## Exception: 1
In data set, two excellon drill files are given "hole_drl" and "via_drl" not clear to us.

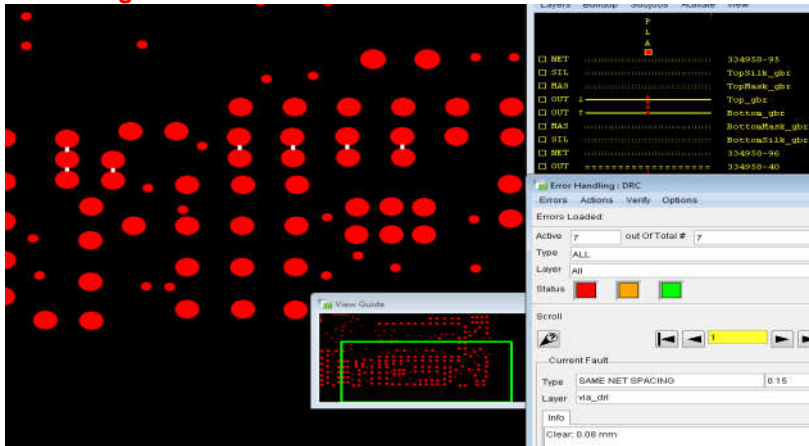
Exception: 2
Minimum drill-drill distance in our Pcb Power Services is 0.15mm.
Your design has drill-drill distance of 0.08mm.

Example errors in white - Not all errors are shown - CHECK your complete design

## Suggested solution :
We request you to make changes accordingly. Refer last page for our capability.

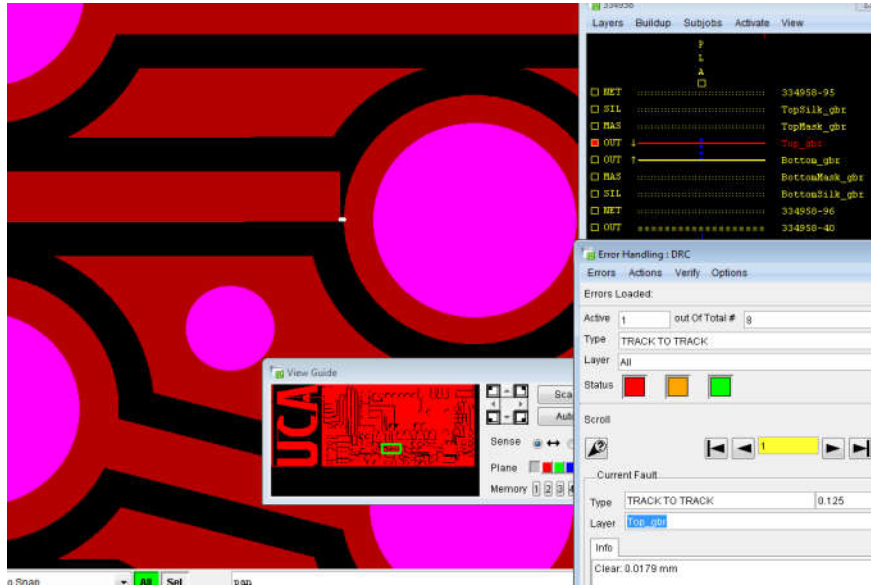
Minimum TT-TP-PP-TW in our Pcb Power service is 0.125mm.
Your design has TT-TP-PP-TW of 0.0179mm.
Total 01 TT-TP-PP-TW errors found which are <0.15mm.

Example errors in white - Not all errors are shown - CHECK your complete design

Can we continue the order by making short where PAD TO TRACK error found?
